Result: Report of the Working Party on Customs Questions affecting Transport on its 133rd session

5. Vehicles with sliding sheets

Documentation: ECE/TRANS/WP.30/2012/6/Rev.2

Guidelines for checking vehicles or containers with sliding sheets

Opening between sliding roof and upper cantrail:

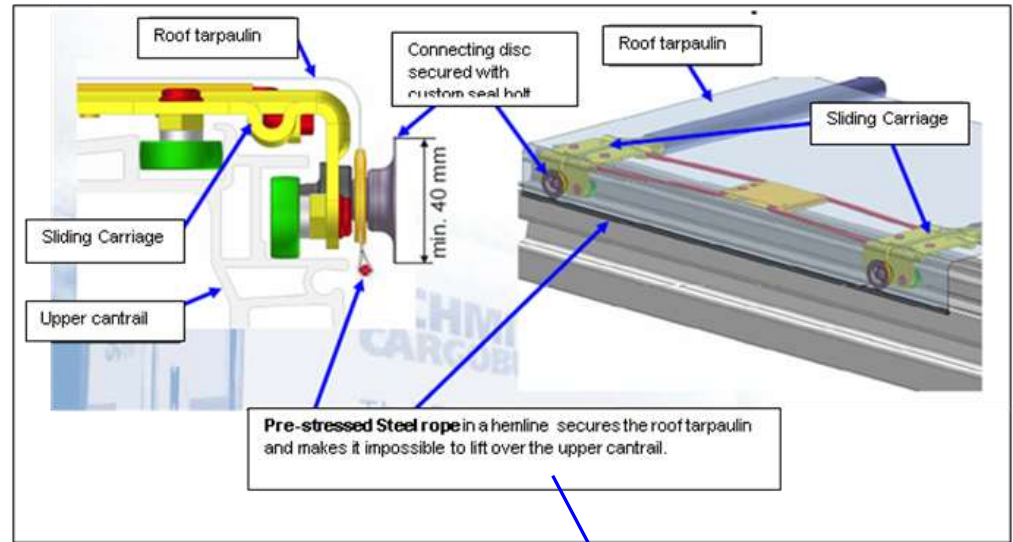
4. For the provision (ii) "... The horizontal opening between the sliding roof and the upper cantrail of the load compartment may not exceed 10 mm...", it is technical wise not possible to pre-stress the rope with this length in such a way that the measurement (10 mm) can be fulfilled. CLCCR asks that this provision should be deleted. The other provisions under point 2 (ii) in the new articles can be kept.

The steel rope in the hemline is more than 16m long and only one part of the securing system. To pre-stress this rope in such a way is not possible and make no sence. The connecting disc, upper cantrail and the pre-stressed steel-rope have to secure the roof together.

(ii).....The horizontal opening between the sliding roof and the upper cantrail of the load compartment may not exceed 10 mm measured perpendicular to the longitudinal axis of the vehicle /container at any place when the load compartment is secured and sealed for Customs purposes.

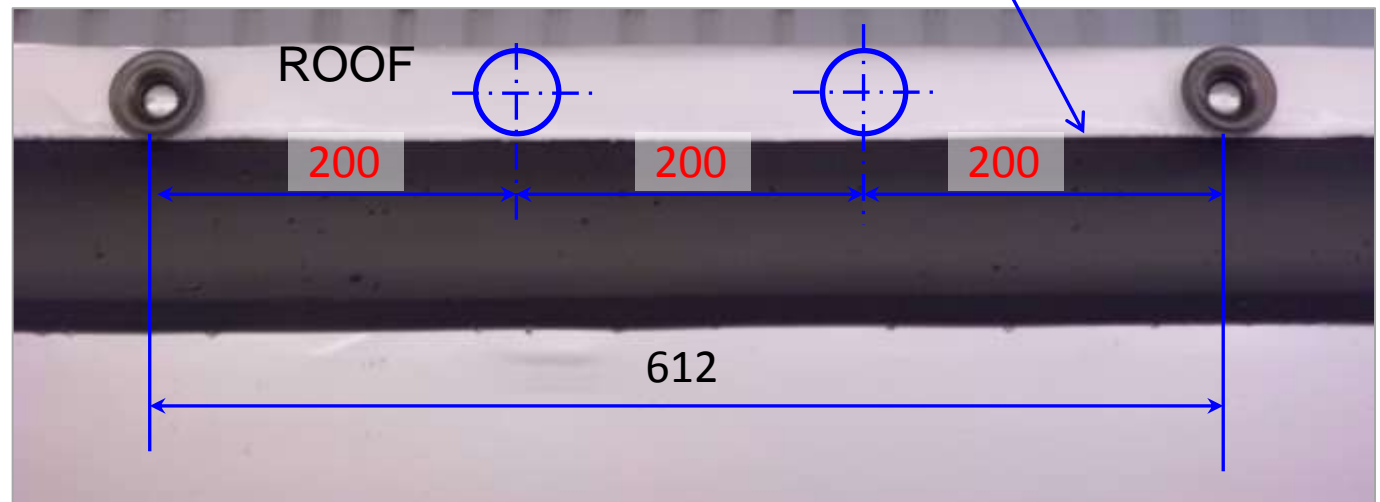
With additional connecting discs (200mm) it is not possible to open the roof to a maximum.

Sketch showing the principle.

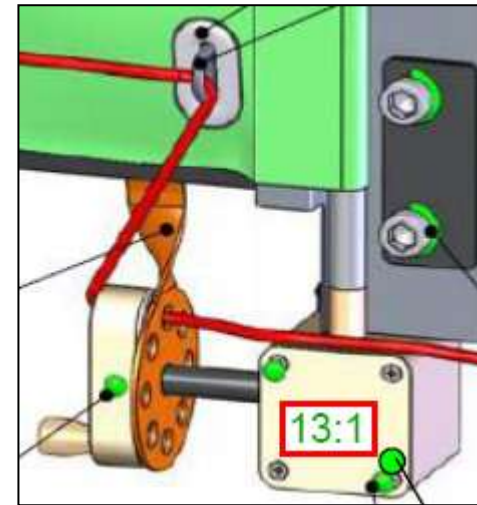
Three or one plate to secure the hand crank?

If the you use three plates you can do it that way. Distance to the hand crank

The plate in the middel is welded to the chassis.

Two plates are welded to the axis.

➔ **Both systems are possible and secure!**
